** MANDATORY ** SERVICE BULLETIN

NO.: 0823 Rev B

GDU 104X CRS/BARO Knob Interference

REVISION B: Removed the GDU 1045 (011-00819-04) and added a list of affected

Figure 3

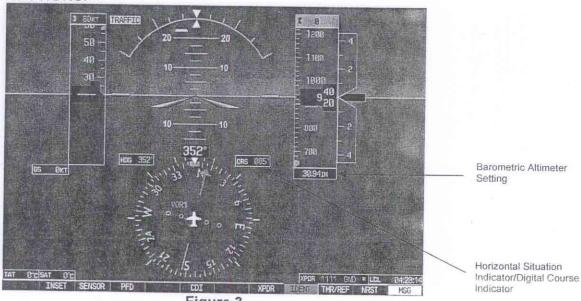
- 4. Rotate the small (inner) CRS knob (refer to Figure 1) a minimum of three complete revolutions in each direction while monitoring the Barometric Altimeter Setting (refer to Figure 3) on the PFD. If a change in the Barometric Altimeter Setting is produced while turning the CRS knob proceed to the Modification Instructions.
- 5. Repeat Steps 3 and 4 for each affected GDU.
